**CRESCENT HEIGHTS**

**ADDENDUM #2**

April 29, 2009

*The following items hereby amend and supersede the plans and specifications dated April 2, 2009 for the above referenced project.*

Drawing E1.1 Tel/IT/G07 Plan

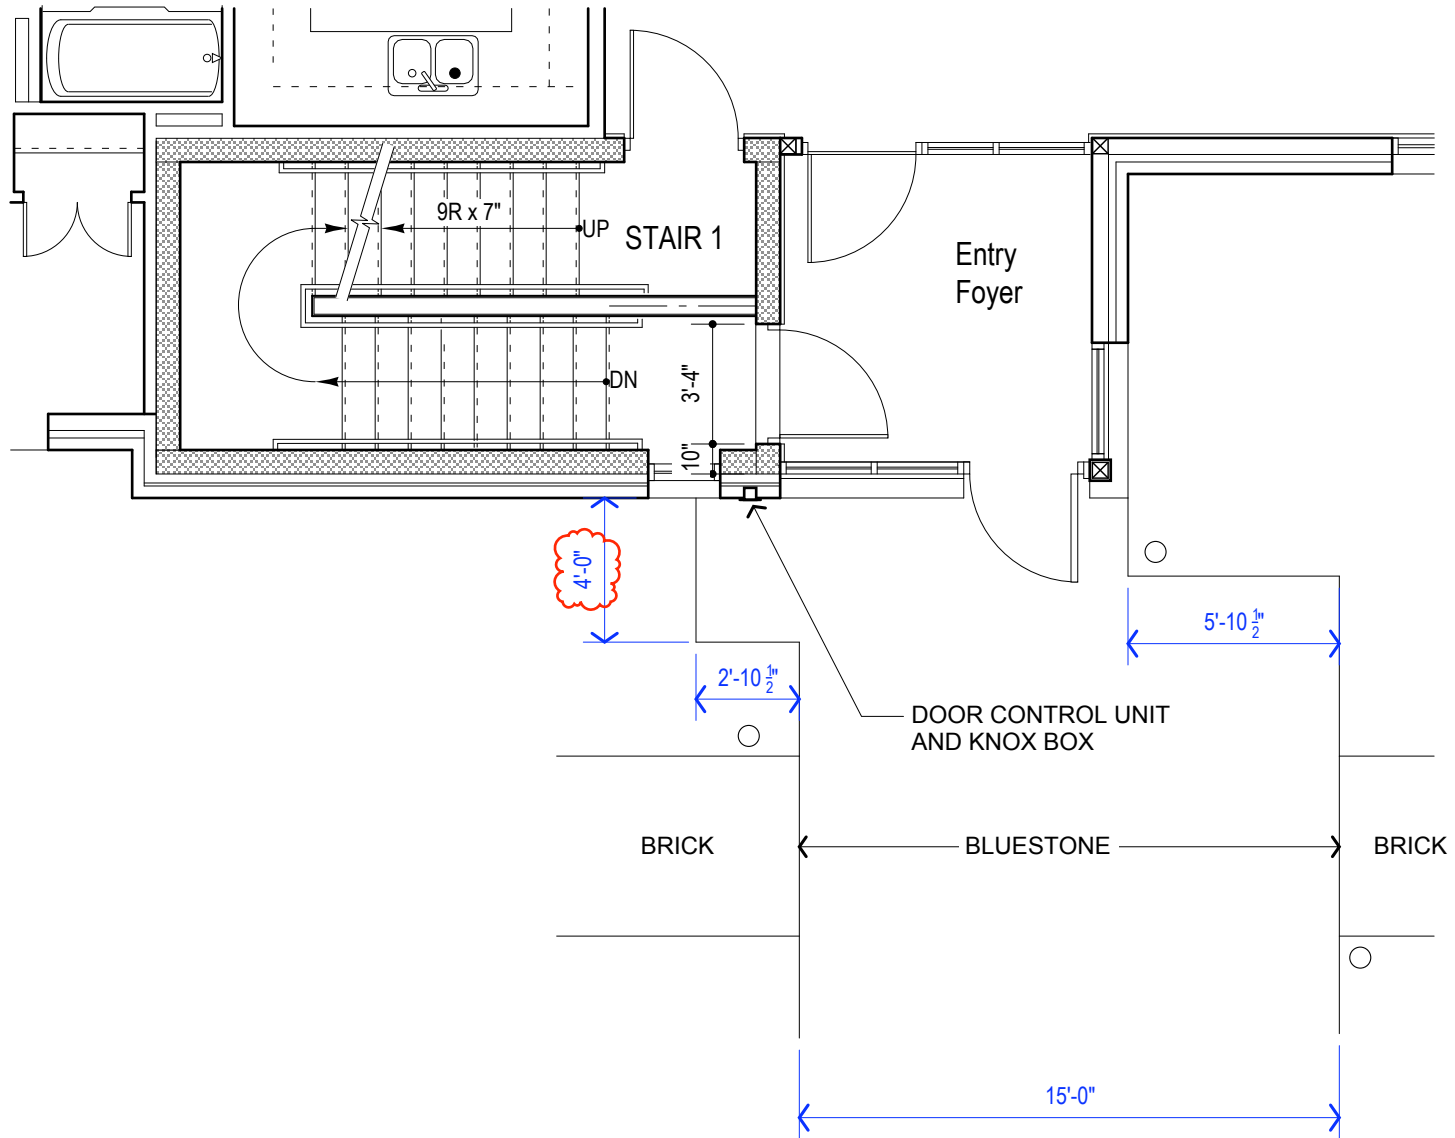
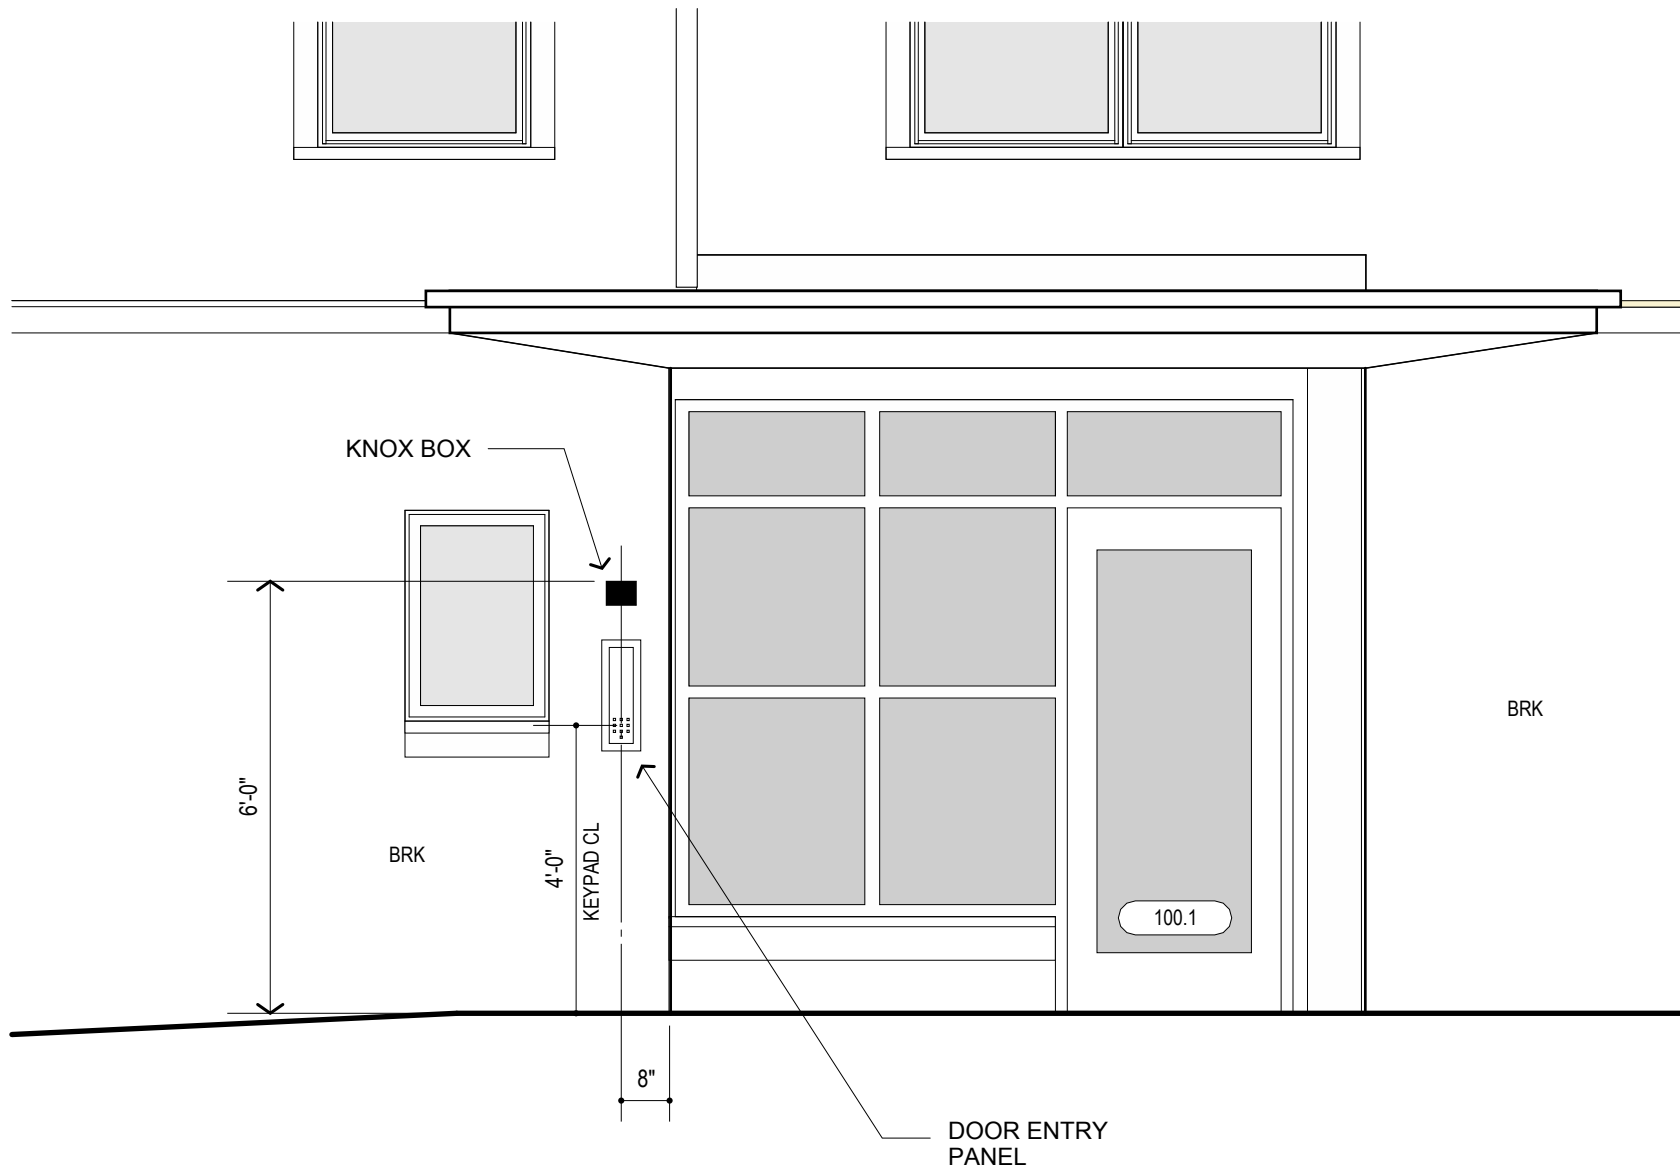
**INDICATE** that the telephone and cable television service demarcation points shall be on the outside wall of the building and that the Contractor shall provide service cable from the demarcation points to the Tel/IT Room (telephone and cable television service shown on this drawing as being routed to Mechanical Room G06 shall be replaced with service cable routing to the Tel/IT Room). Local telephone/cable television cabling drops shall be terminated at the Tel/IT Room.

**DELETE** the references to the municipal fire alarm service cable.

SKS-4

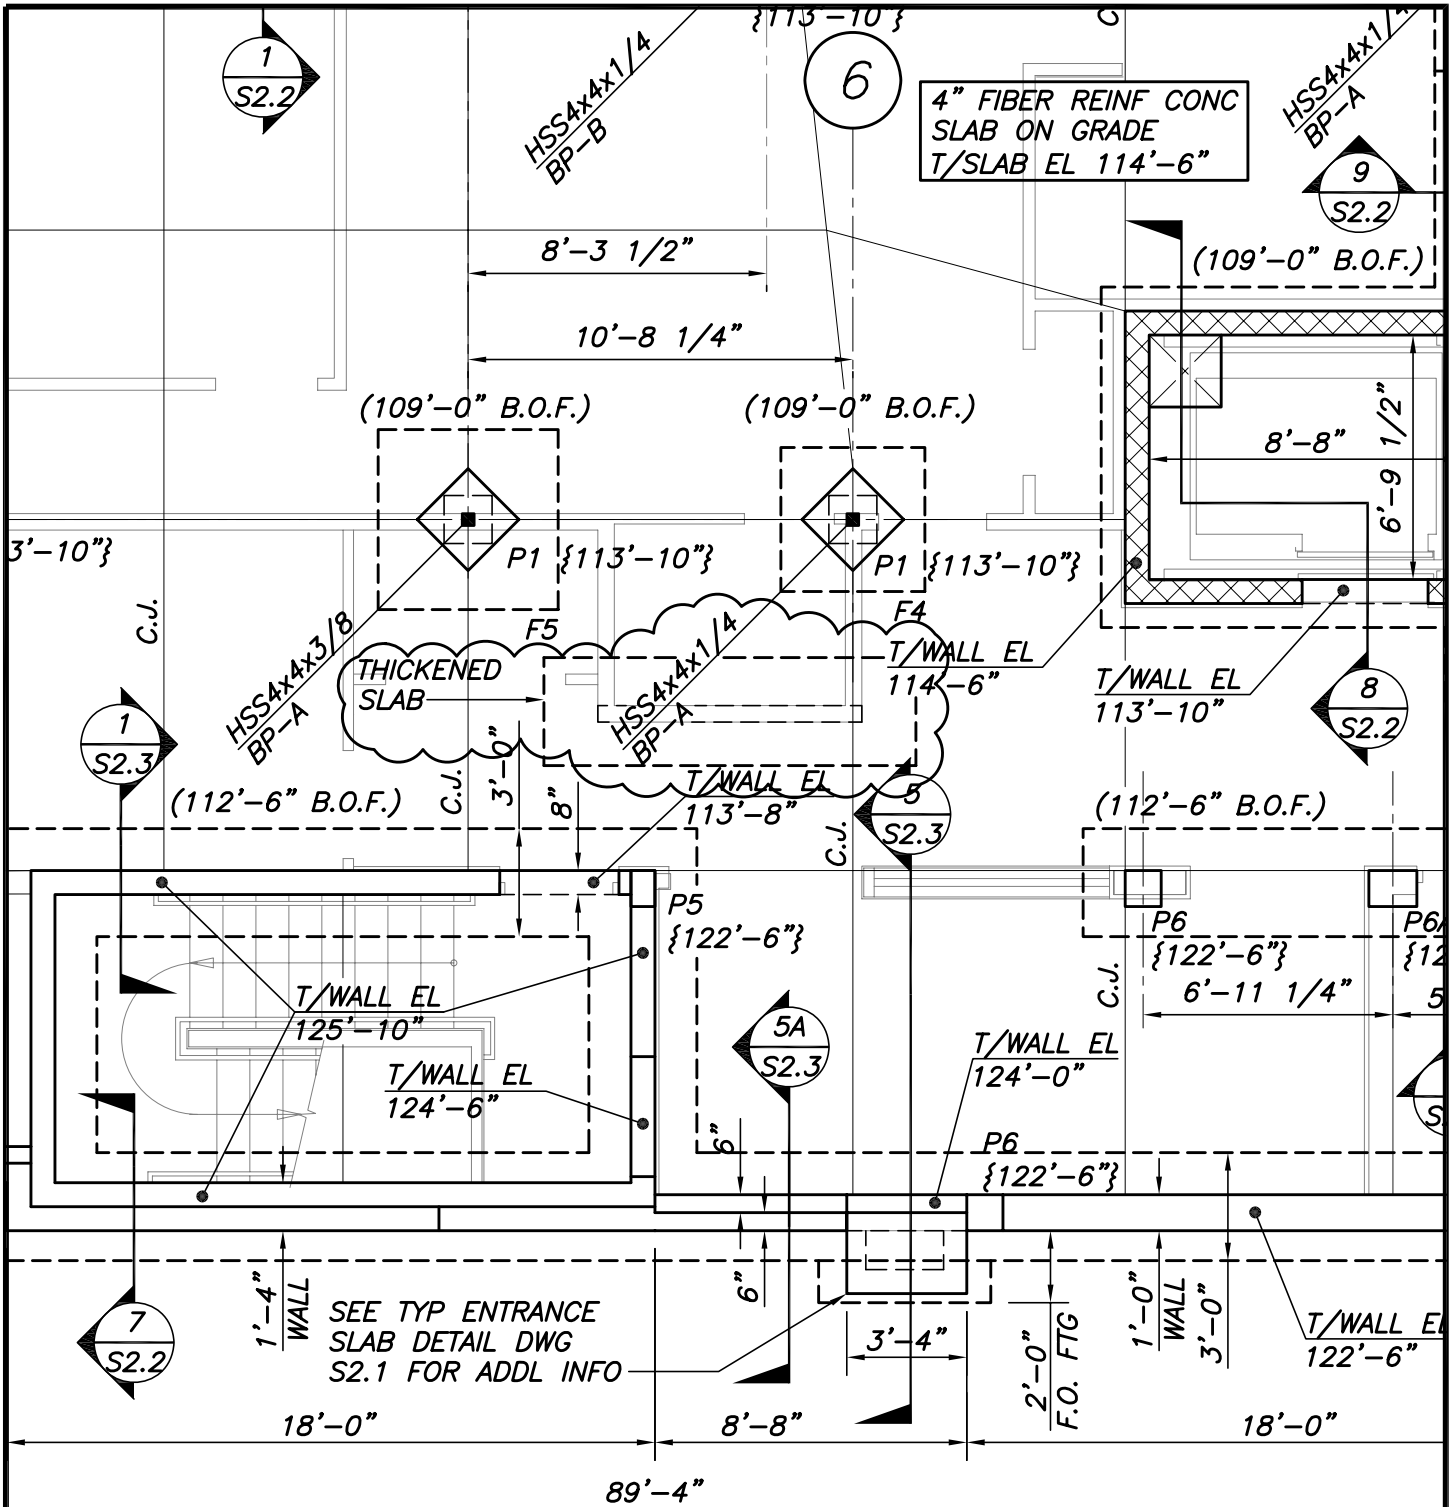
NOTE REVISED LAYOUT TO ALLOW BEARING WALL OPENINGS TO ALIGN VERTICALLY. SEE SKS 4 FOR ADDED FOOTING. EXTEND DRYWALL TO DECK AT CORRIDOR WALLS TYPICAL

**FC-1 MODIFIED (MECHANICAL PLAN - FIRST FLOOR)**

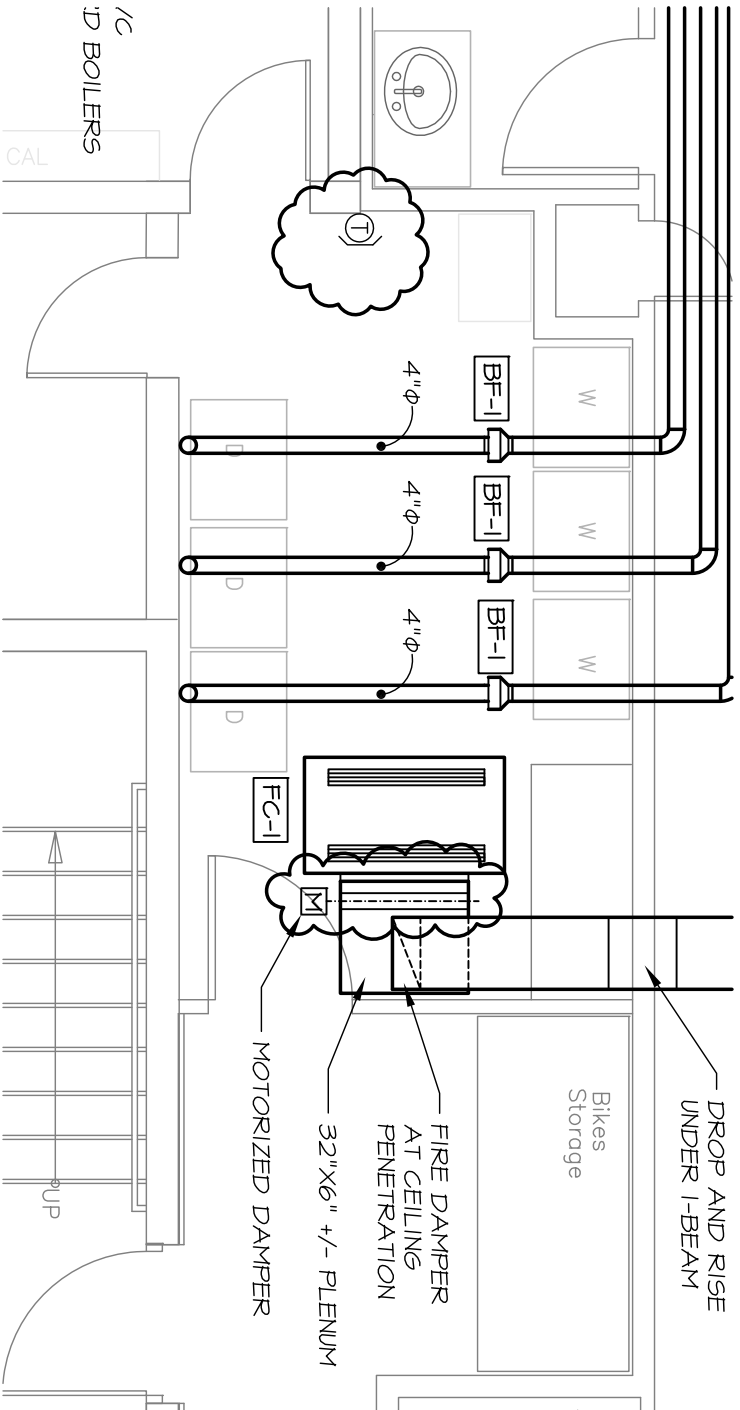
- Add Sketch SKM-5.1
- Change Specification *230000 Mechanical* as follows

Change *2.15 Cabinet Unit Heaters* to read  
*2.15 Cabinet Unit Heaters and Fan Coil Unit.*

Add to the *2.22 Automatic Temperature Controls (ATC), N. Description of Operation.*

9. Fan Coil Unit FC-1
  - a. Wall-mounted thermostat to open zone valve and activate fan on a call for heating.
  - b. When any of the BF-1 pressure contactors close, open damper on outside air louver. Note - each of the BF-1 dryer exhaust vent blowers will have a factory supplied and installed pressure switch.
  - c. Install freeze stat in ductwork to close outside air damper if freezing conditions are measured.
